Urgent Field Safety Notice
Synergy™ Cranial (9733763) and StealthStation™ Cranial (9735585)
Biopsy Depth Gauge Cycle View Inaccuracy
 Notification

Medtronic reference: FA1204

Figure 1 Biopsy Depth Gauge Inaccuracy seen in Navigate Task

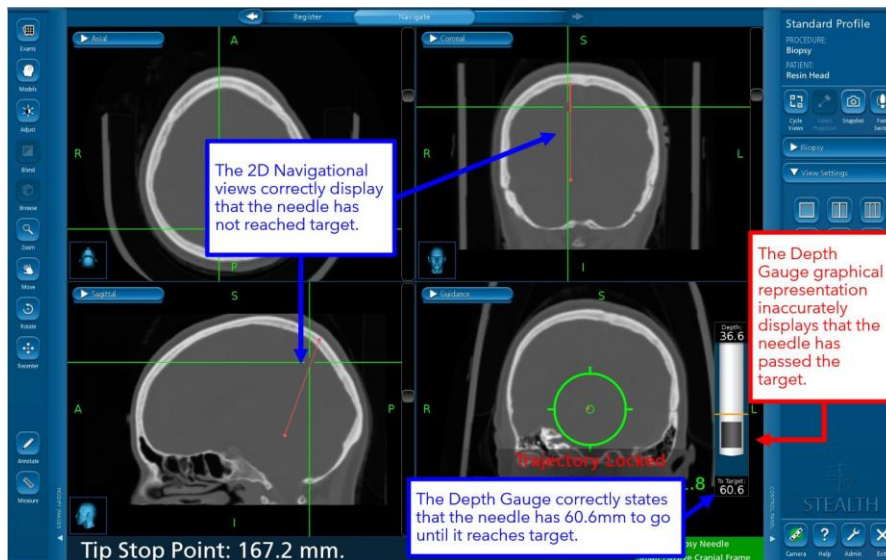
On June 9, 2021, a complaint was reported to Medtronic that during navigation in a Cranial Biopsy Procedure, the user may encounter an anomaly with the Biopsy Depth Gauge graphical display in the software. The software can enter a state where the Biopsy Depth Gauge is no longer synchronized with the rest of the navigational information on the screen and displays an inaccurate position of the biopsy needle.

If performed, these actions may cause the Biopsy Depth Gauge graphical display to incorrectly depict the tip of the biopsy needle. The graphical depiction of the biopsy needle may appear in a position relative to the plan target that does not represent the actual physical position of the biopsy needle, which may result in potential biopsy of healthy tissue or damage to critical structures.

- Medtronic recommends **NOT** turning off **Guidance View** after locking the biopsy trajectory in the Cranial software.
- After locking trajectory for biopsy needle navigation, always ensure **Guidance View** remains an active view in at least one screen layout quadrant.

- **Step 1:** Obstruct the camera field of view of the biopsy needle or reference frame to **cause red status**.
- **Step 2: Return to green status** by no longer obstructing camera field of view of the biopsy needle and reference frame.
- **Step 3:** Use the **Cycle Views** icon to refresh guidance view and confirm that the biopsy depth gauge graphic matches the distance to target values and the position to target information provided by the 2D crosshairs.
- **Step 4: Visually confirm accuracy** before proceeding with navigation.
